## **HOUSATONIC RIVER**

### **MODEL VALIDATION**

#### **FINAL COMMENTS**

Wilbert Lick  
University of California  
Santa Barbara, California

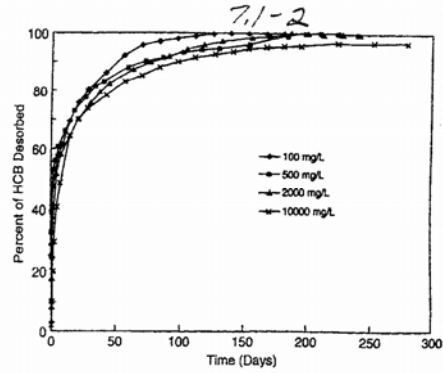
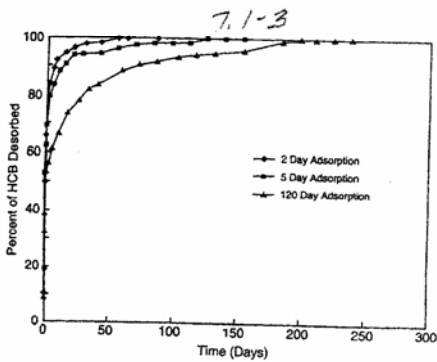
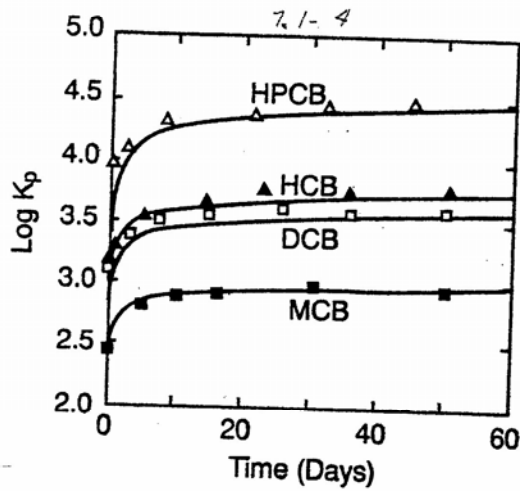
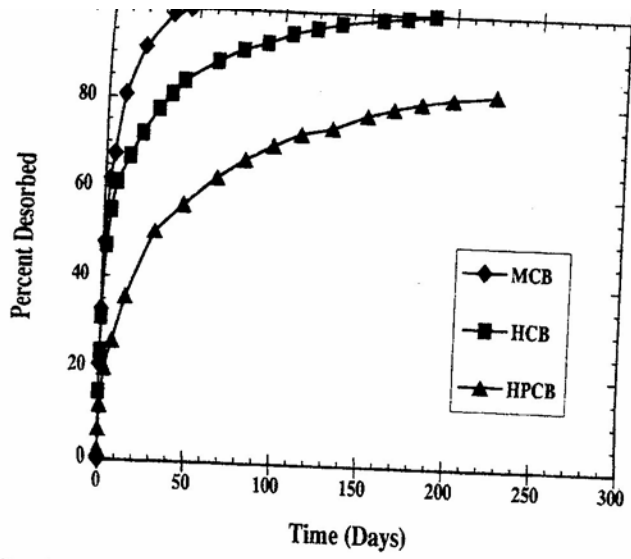
Some experimental results for the adsorption and desorption of HOCs are shown in the appended figures. These sorption times depend on the sediment concentration, particle and floc sizes, conditions of the experiment, and the value of the partition coefficient. The first three figures are for hexachlorobenzene ( $K_p = 10^4$  L/kg), while the fourth figure is for the adsorption of HOCs with  $K_p$ 's from  $10^3$  to  $6.6 \times 10^4$  L/kg. The last figure is for the desorption of a PCB with one chlorine (MCB,  $K_p = 10^3$  L/kg), hexachlorobenzene (HCB,  $K_p = 10^4$  L/kg), and a PCB with six chlorines (HPCB,  $K_p = 6.6 \times 10^4$  L/kg, a  $K_p$  which is smaller than, but comparable to, the average  $K_p$  of about  $10^5$  L/kg for PCBs in the Housatonic). In 10 days, only about 25% of the HPCB has desorbed; in 50 days, only about 55% has desorbed. As the partition coefficient increases, the amount of desorption in these time intervals will be even less. For PCBs with  $K_p = 10^5$  L/kg, the desorption times would be approximately 1.5 times greater than those for HPCB shown here.

Since desorption times are much greater than settling times, it follows that contaminants on resuspended particles will not desorb completely, or even close to completely, in the water column before the particles settle out of the water column. The chemical sorbed to the suspended particles will therefore not reach chemical equilibrium with the chemical dissolved in the water column. It follows that the assumption of equilibrium partitioning is not valid, nor even a good approximation, for the sediments in suspension or in the surficial layers of the bottom sediments.
